No. 98800-020 Rev.1 Machine: 800/810 System: CHASSIS

STEERING CYLINDER MOUNT BRACKET

FIG. 1 - Steering Cylinder Bracket

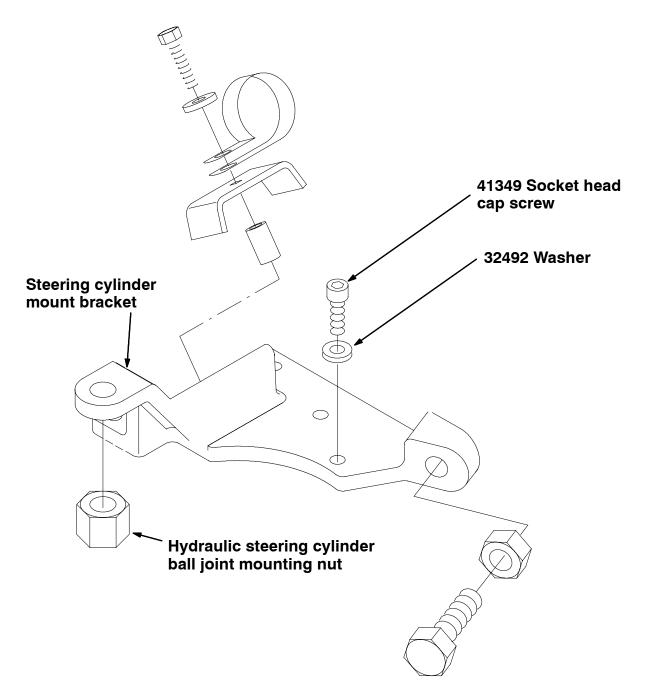
The 800/810 steering cylinder mount brackets and rear wheel support are subjected to severe centrifical forces when a machine makes a u-turn. Be sure to inspect all hardware for the steering bracket and rear wheel support when performing maintenance on a machine. Be sure to check for loose or damaged components. The machine could possibly have the wrong hardware or the improper torque on the screws that mount the steering cylinder bracket to the rear drive support casting.

The new updated production 800 machines above serial number 4000 and 810 machines above serial number 3000 feature a more robust steering bracket #375575 and larger M12 mounting socket screws #375576, and washers #32403. The rear wheel support has also been improved. If a machine needs to have the steering bracket or rear wheel support replaced, order kit 375534. This kit includes all parts to update an older machine and will provide improved steering performance.

Use the procedures below only if working on 800 machines below serial number 4000 or 810 machines below serial number 3000 with early style steering bracket and M10 socket head screws.

- 1. Raise the seat.
- 2. Locate the steering cylinder mount bracket on the top of the rear drive casting. (Refer to Fig. 1)
- 3. Check the hardware attaching the bracket to the casting. This hardware should be **SOCKET HEAD CAP SCREWS** (part # 41349), M10-1.5x30mm long with 3/8 **flat washers**, (part # 32492). If any other type of hardware is installed, remove and discard. (Refer to Fig. 1)
- 4. On some machines the tapped holes may have dirt and shavings trapped in the holes. This debris can prevent proper engagement of the hardware.
- 5. The proper depth of the threaded hole should be 7/8 inch. Us a small ruler or scale to check this.

- 6. Any debris must be throughly cleaned out of the tapped holes.
- 7. Apply red locktite 271 (part # 19857) to the tapped holes and install the socket head cap screws. The proper torque is 46-60 ft lb (63-81 Nm).(Refer to Fig. 1)
- 8. Check the hydraulic steering cylinder ball joint mounting nuts for proper torque. The torque should be 215–280 ft lb (290–380 Nm).
